DESIGN REVIEW COMMITTEE

February 18, 2026 6:00 PM

AGENDA

ScaleAs indicated

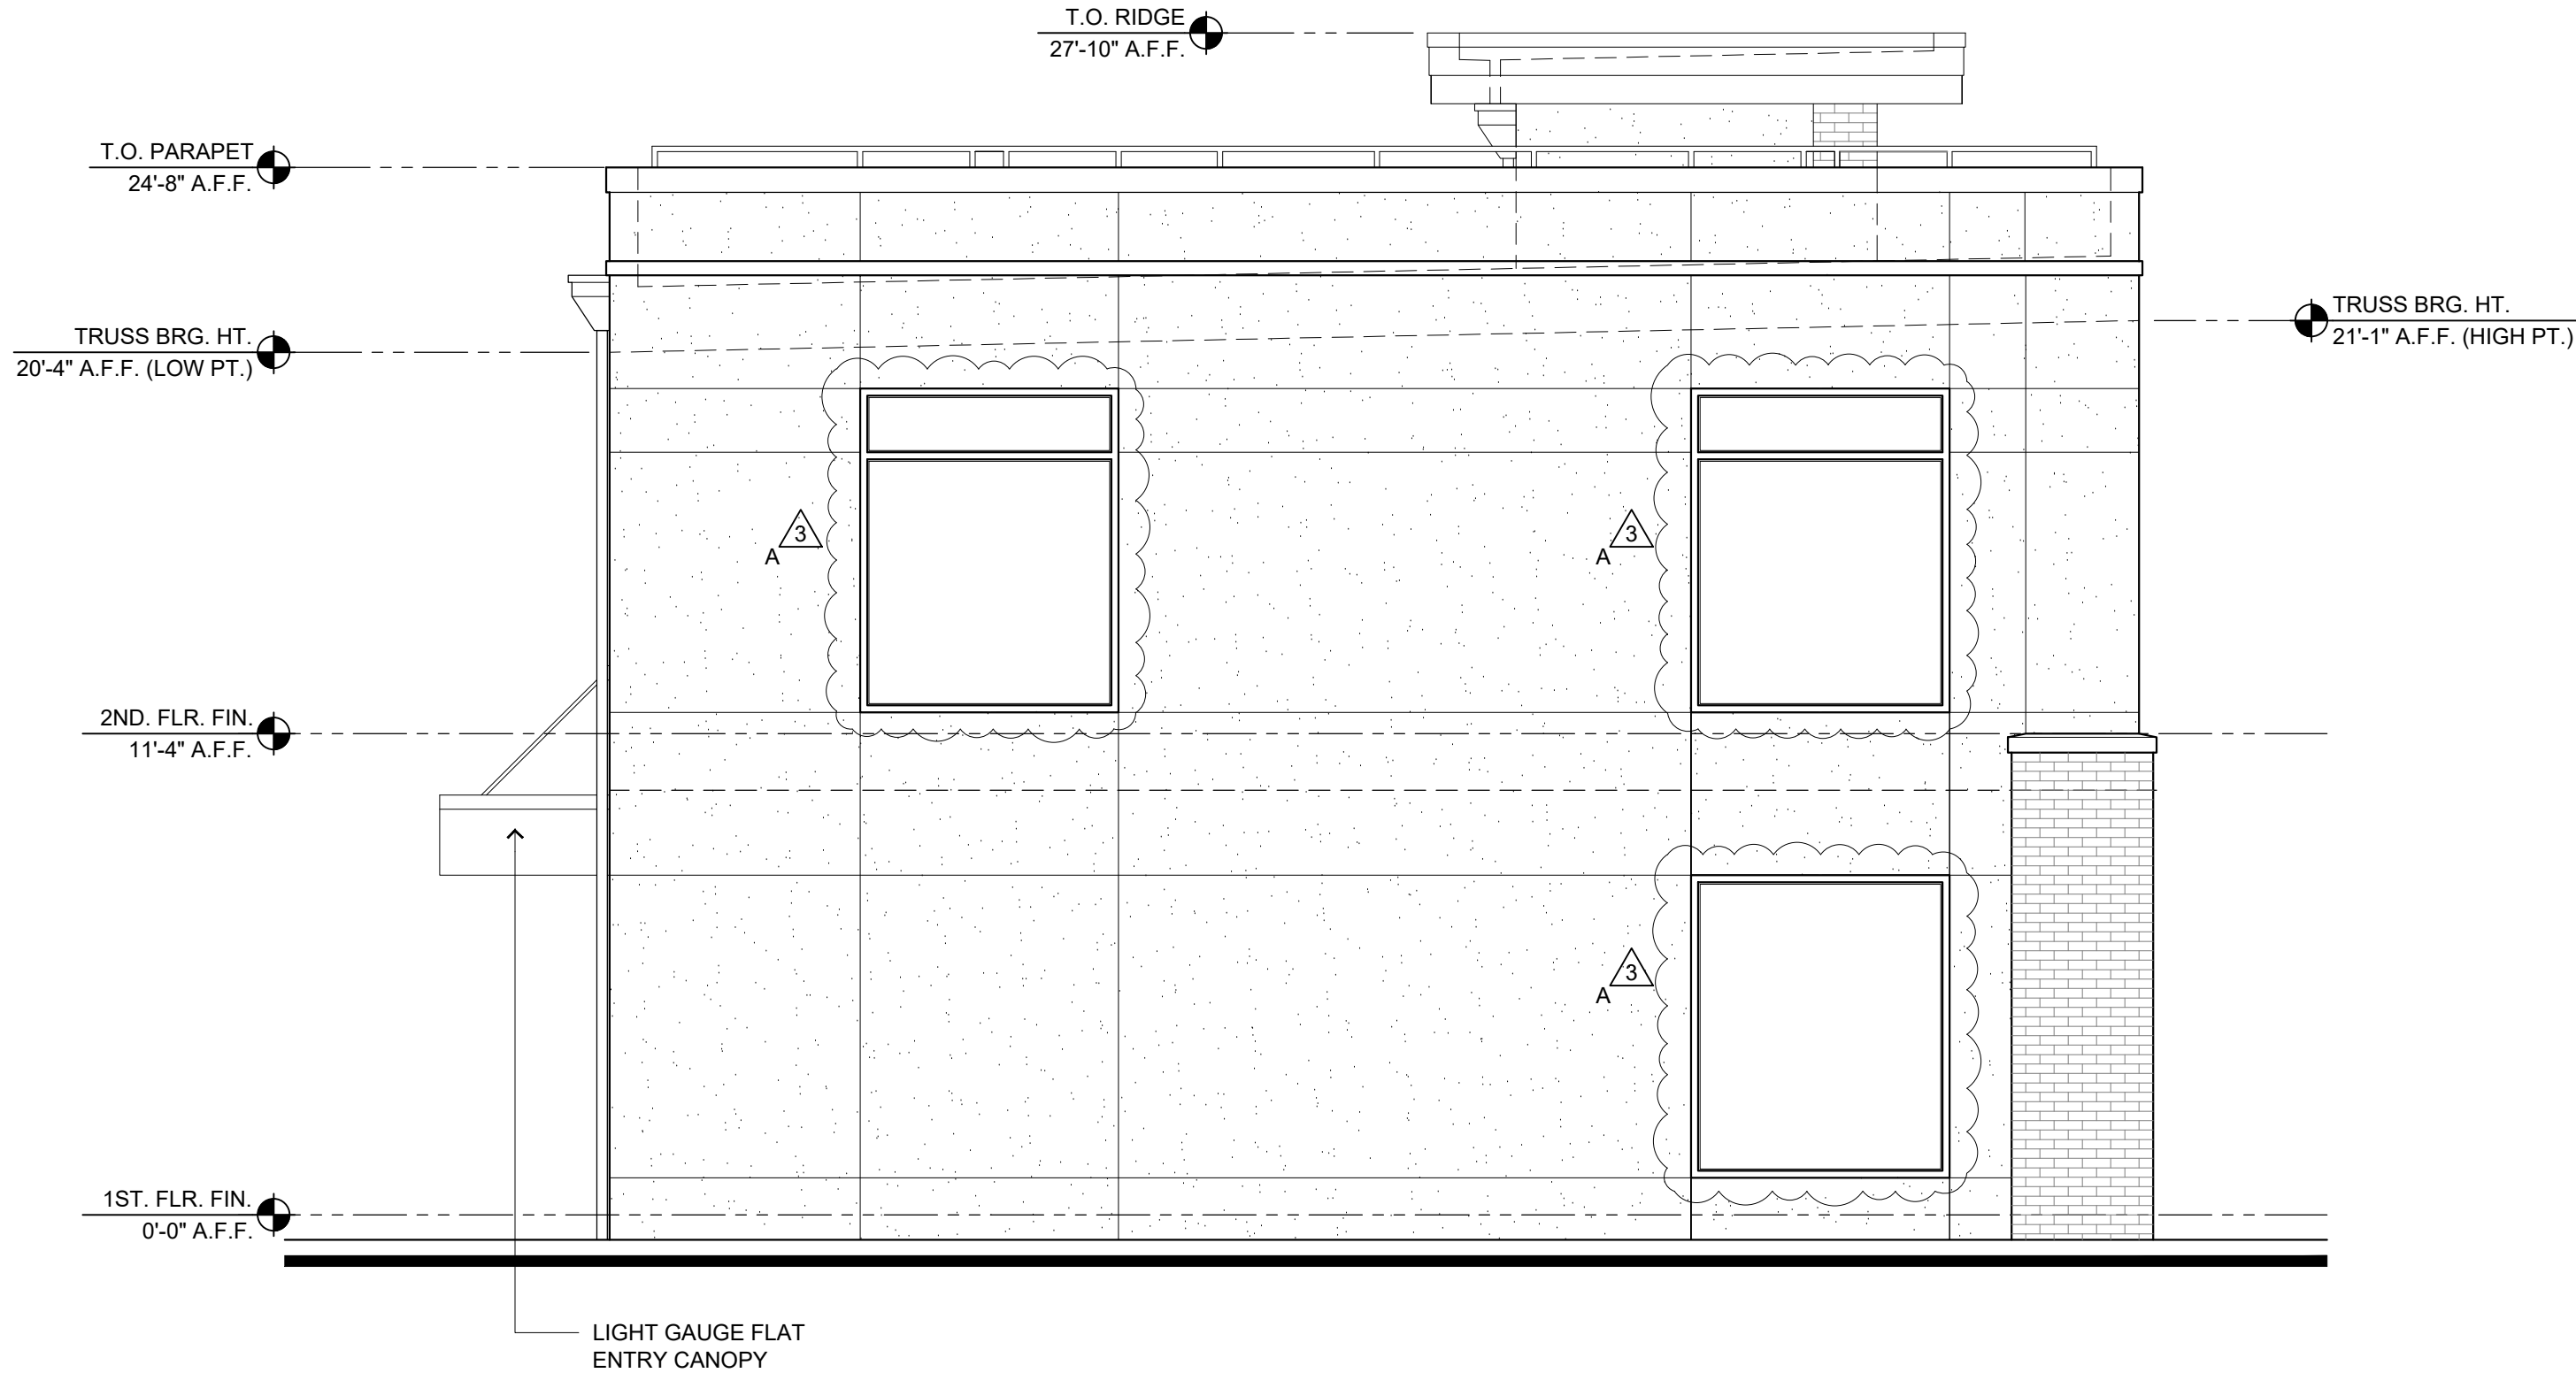
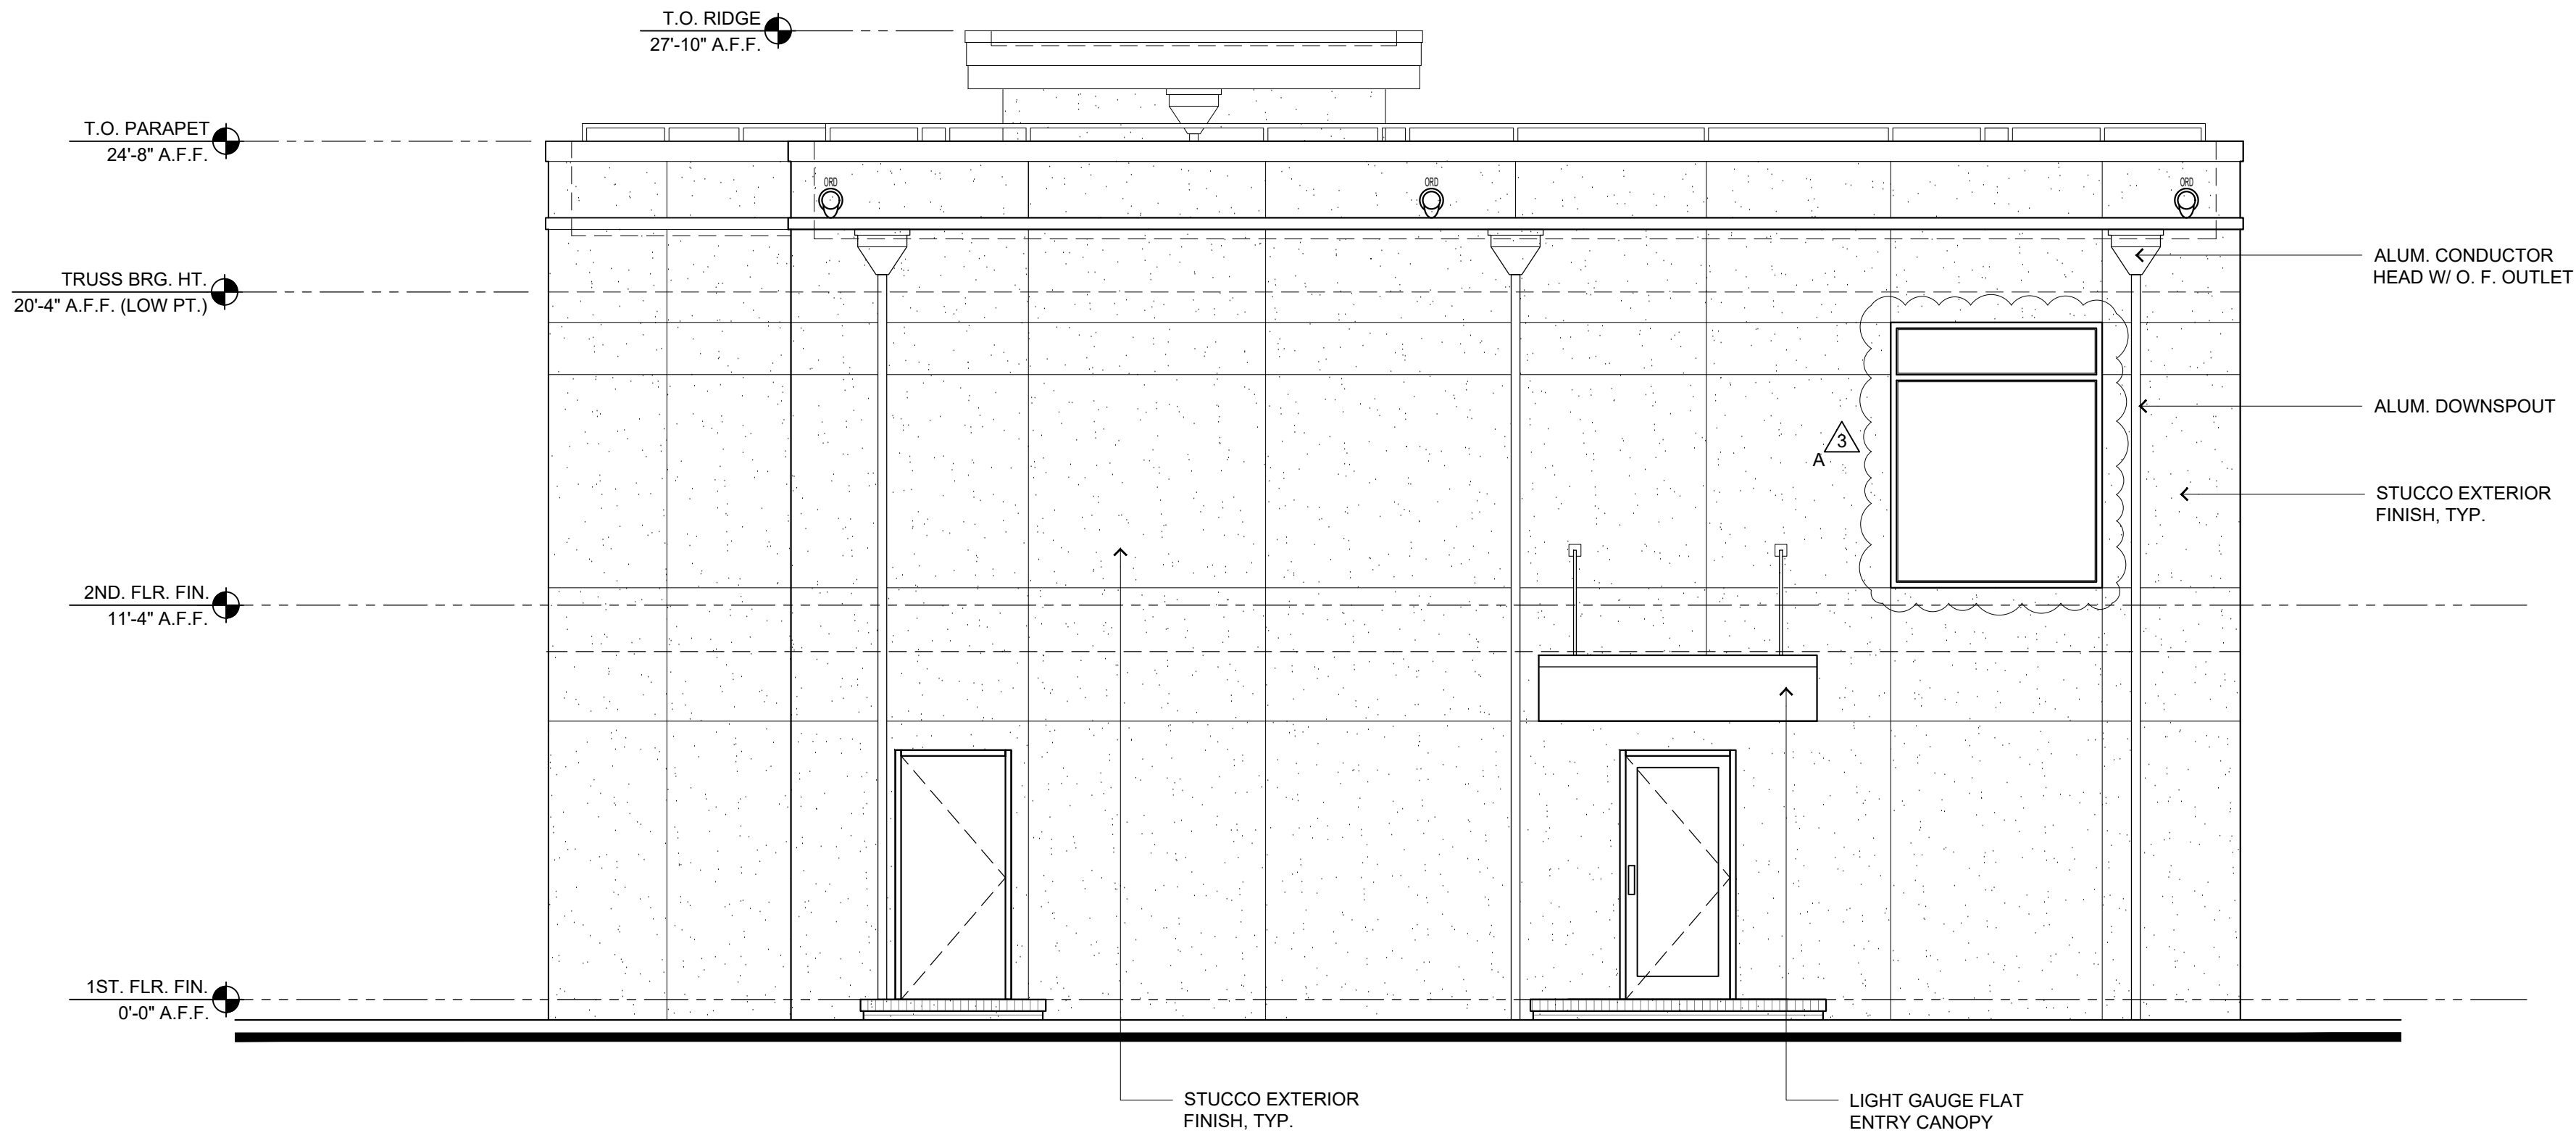
The requested change is to modify the windows from divided light windows to large pane windows on the lower and upper floors and to install transoms on the upper story windows. The applicant has also removed the grid from the center window and is proposing three separate panes (is it unclear if this is one large pane with applied horizontal muntins or three separate panes). Finally, the single door with sidelights and transoms is proposed to be replaced with a double door with glass and no transom.

The applicant appeared before the Design Review Committee in January 2026 and was asked to return with an alternative plan as the windows were not oriented vertically as required by Code. As Mr. Harris stated at the meeting that the windows had been ordered, a recommendation from a Committee member during the meeting was to bring by a design to address verticality that included realigning the lower windows and adding transoms to align with the front door and adding transoms to the upper window. This was not a conditioned approval but rather an opportunity for the applicant to provide a design that addressed the required verticality.

The applicant has returned with an alternative design that adds only transoms to the upper-story windows to achieve verticality. The Architectural Design Standards require that upper-story windows shall be vertically oriented, with a height greater than their width, including display windows but not transoms. If the proposed window modifications are acceptable to the Committee, a Design Exception would be required.

The Design Review Committee may assess whether the revised windows meet the intent of the storefront treatment as prescribed in the Standards.

REVISION #3
A. ADDED TRANSOM
B. REVISED ENTRY DOOR UNIT
C. REVISED WINDOW MULLIONS

REVISION #2
A. REMOVED WINDOW MUNTINS

FRONT ELEVATION COMPARISON

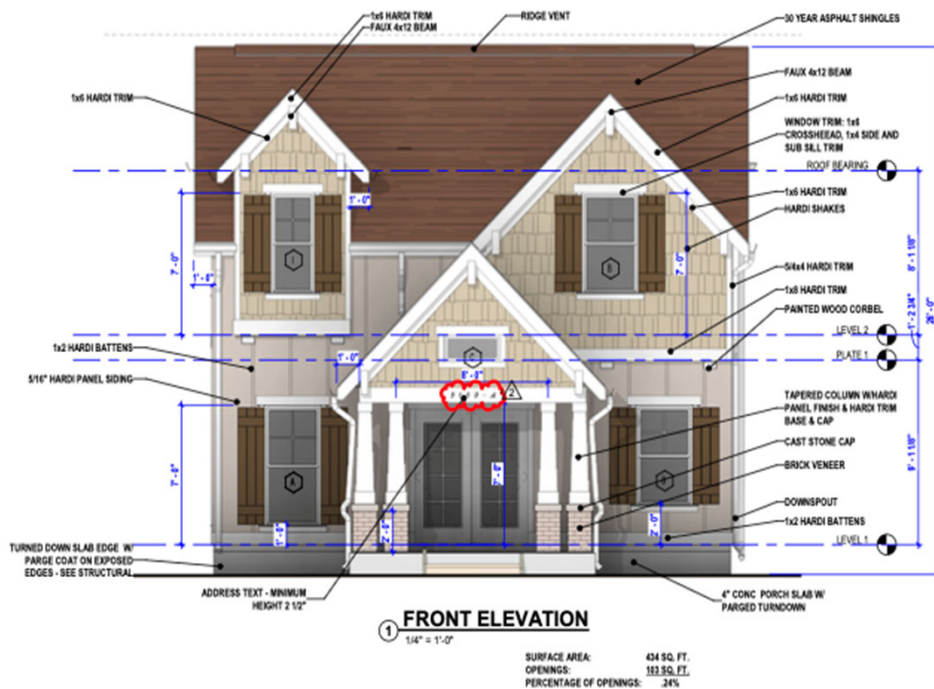
- Remove divided lights
- Remove shutters
- Remove tapered columns and brick veneer allow for post columns.
- Allow for box soffits instead of sloped soffits
- Allow for single door instead of double door
- Remove porch railings as not required by Code.

City of Hapeville Design Review Committee Design Revision Recommendations					
3189 A Jackson Street					
Site Plan Page	Elevation	Approved Plans	As Built	Justification for As Built	Recommendation
A0.0	Front	Installation of concrete walkway front center and right side of porch	Concrete sidewalk built on right side	Clean outs and grade	Build to specs on approved plans
A1.0	Front	Parged coat/finishing on concrete slab on front and side elevations	No parged coat/finishing on concrete slab and exposed side elevations	N/A	Build to specs on approved plans
A1.1	Rear Elevation	Painted wood railings and window trim	No paint on wood railings and window trim	N/A	Paint/stain back deck per approved plans and add window trim
A1.1	Window Schedule	Window mutins to be factory applied on glazing	No window mutins	Builder ordered grid less windows	Leave as built
A2.0	Front	Faux trim, corbels and window trim	No shutters, faux trim, corbels, tapered columns or brick veneer was installed	n/a	Build to specs on approved plans

A1.0	Front	Shutters	No Shutters	n/a	Seeking approval to leave off shutters, tapered columns and brick veneer
A1.0	Front	Sloped (raked) Soffits	Flat (Boxed) Soffit	N/A	Seeking approval to leave as built
A1.0	Front	Tapered Columns and brick veneer foundation	Symmetrical columns without brick veneer foundation	Tapered columns have minimal impact on overall aesthetics and modern craftsman character	Seeking approval to leave as built
A1.0	Front	Double Doors	Single Doors		Leave as is
	Landscape Plan	Plant two permitted trees	No trees planted	N/A	Plant per approved tree conservation plan
3189 B Jackson Street					
Site Plan Page	Elevation	Approved Plans	As Built	Justification for As Built	Recommendation
A1.1	Level 1 Floor Plan	Porch has wood railings across the front and sides	Built without porch railings	N/A	Seeking approval to leave as built
A2.0	Front	Faux trim and window trim.	No faux trim and window trim	N/A	Build to specs on approved plans

RIGHT/LEFT SIDE & REAR ELEVATIONS

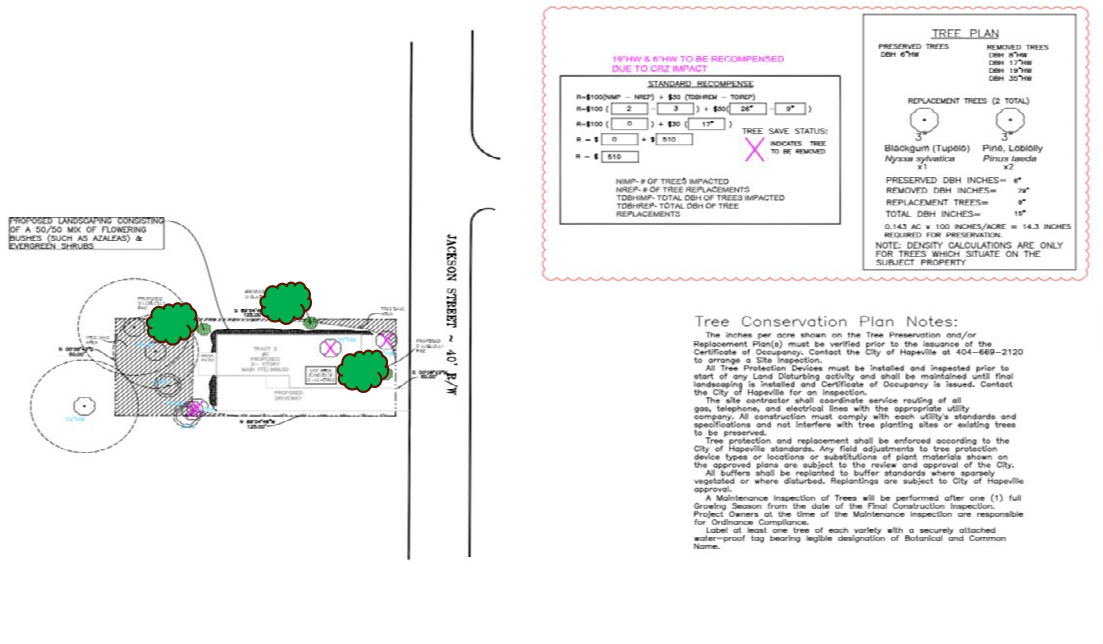
Site Plan Page	Elevation	Approved Plans	As Built	Justification for As Built	Recommendation
A1.1	Level 1 Floor Plan	Porch has wood railings across the front and sides	Built without porch railings	N/A	Seeking approval to leave as built
A2.0	Front	Faux trim and window trim.	No faux trim and window trim	N/a	Build to specs on approved plans
A1.0	Front	Sloped (raked) Soffits	Flat (Boxed) Soffit	N/A	Seeking approval to leave as built
A1.0	Front	Double Doors	Single Doors	N/A	Seeking approval to leave as built
A1.0	Front	Shutters	No Shutters	N/A	Seeking approval to leave off shutters
A1.0	Front	Tapered Columns and brick veneer foundation	Symmetrical columns without brick veneer foundation	Tapered columns have minimal impact on overall aesthetics and modern craftsman character	Seeking approval to leave as built
A2.0	Left Side Elevation	Porch railing	Porch railings not installed	N/A	Seeking approval to leave as built

A2.1	Rear Elevation	Painted wood railings and window trim	No paint on wood railings and window trim	N/A	Paint/stain back deck per approved plans and add window trim
	Landscape Plan	Plant two permitted trees	No trees planted	N/A	Plant per approved tree conservation plan

- **Install window trim**
- **Stain back deck**
- **Concrete parged coating as needed**
